University of the Philippines OPEN UNIVERSITY

SUPPLEMENTAL BID BULLETIN NO. 24-008

This Supplemental Bid Bulletin No. 24-008 is to amend or modify items in the Bid Documents and in response to the queries raised during the pre-bid conference conducted on 04 April 2024 for “Completion of the Convention Hall of the International Convention Center” to wit:

WALL FINISH SCHEDULE
DECORATIVE WALL PLAN
 SCALE 1:50M

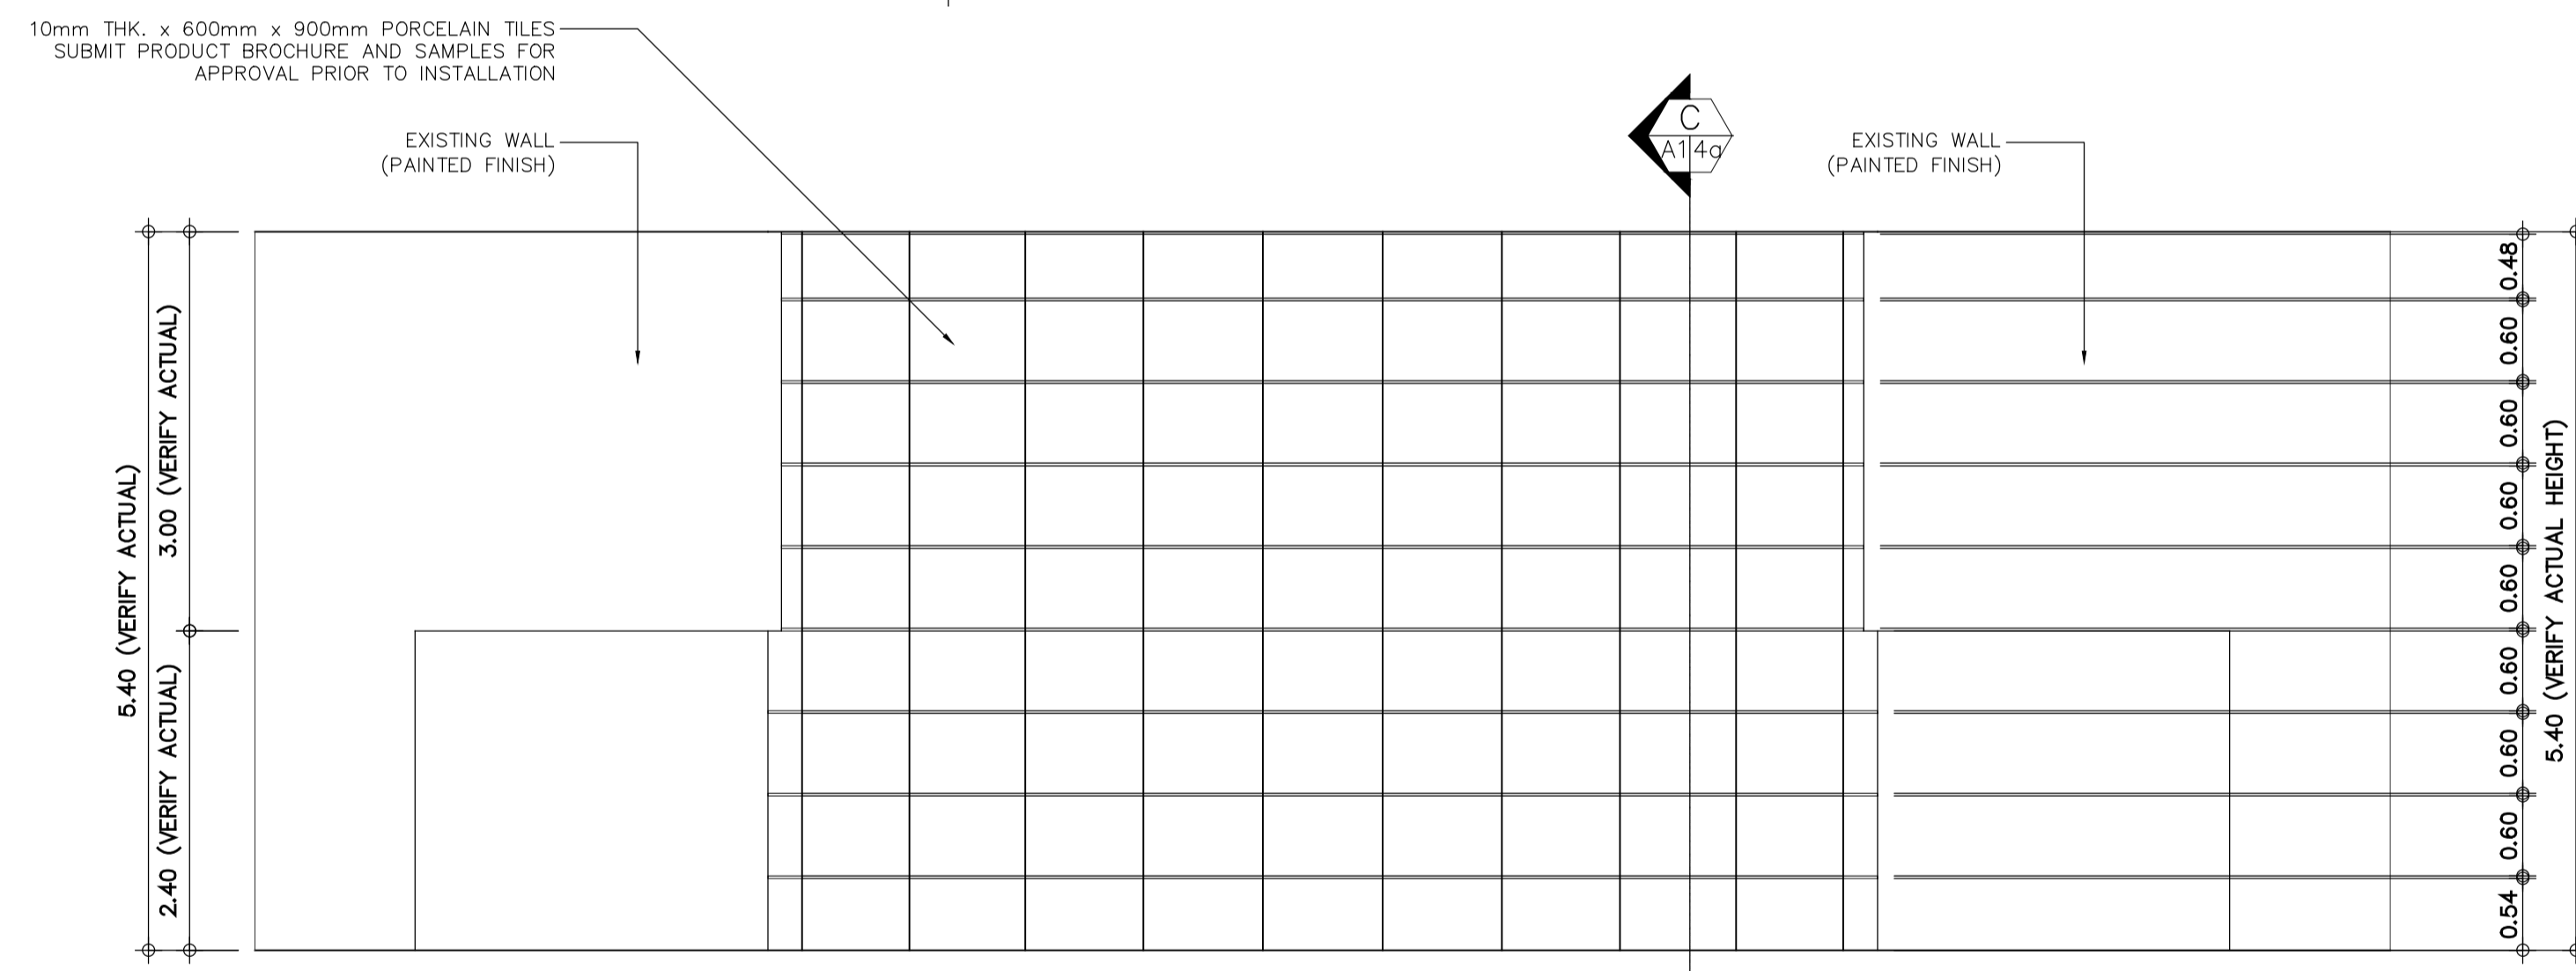
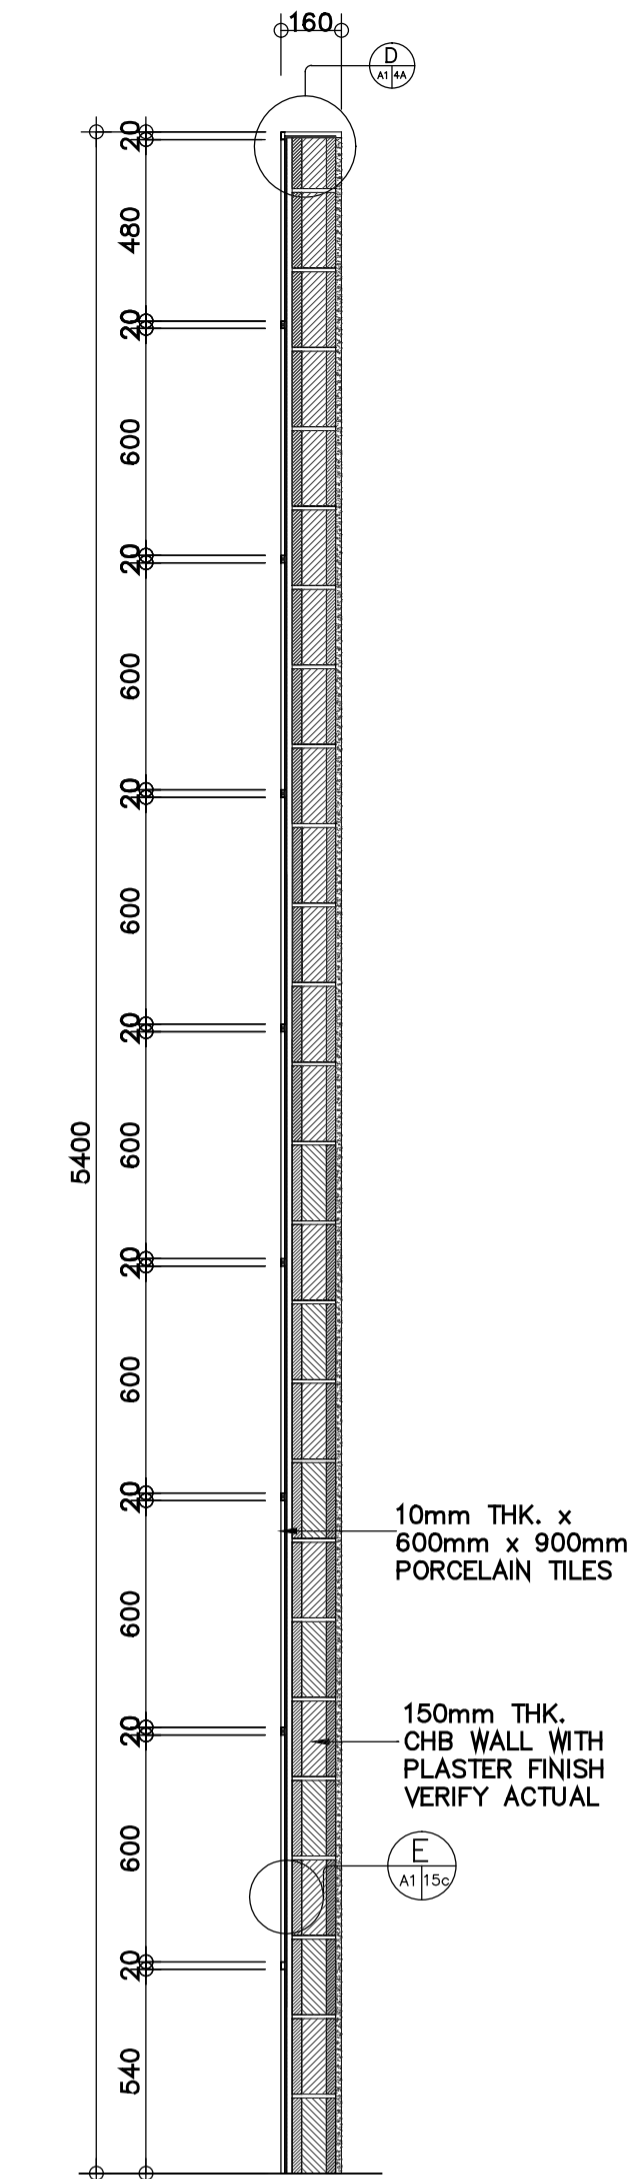
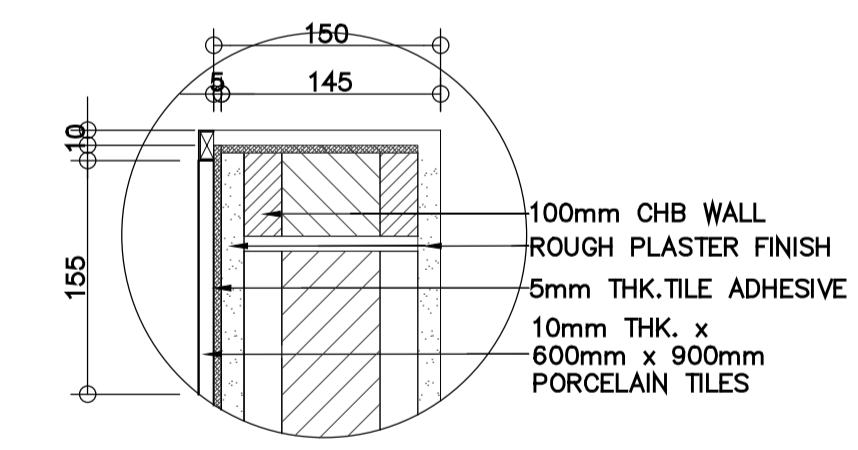
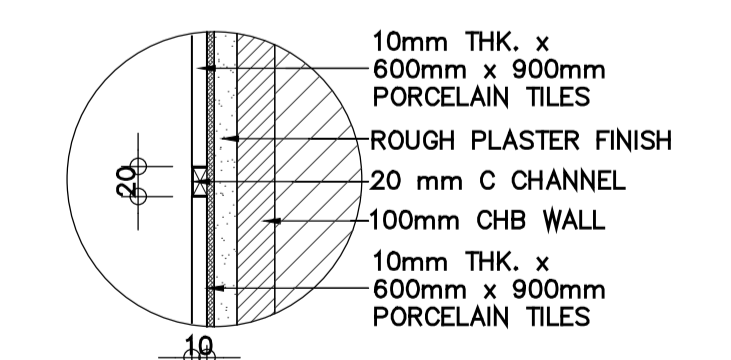
4. Plans, drawing details and specification of the: E. Furnishing 1. a. Decorative Front Wall: Shall be 150mm thick/100mm thick CHB interior wall with 1000mm thick 600mmx900mm anti-stain, matte finish homogeneous porcelain tiles with 1.5mm thick x 10mm x 20mm stainless steel C-Channel in hairline finish	Refer to the A1-4a for reference. The contractor should submit a shop drawing for the tile layout based on the actual/existing conditions, for approval, prior to installation. Refer to the updated A1-4 for location and specification details for reference.
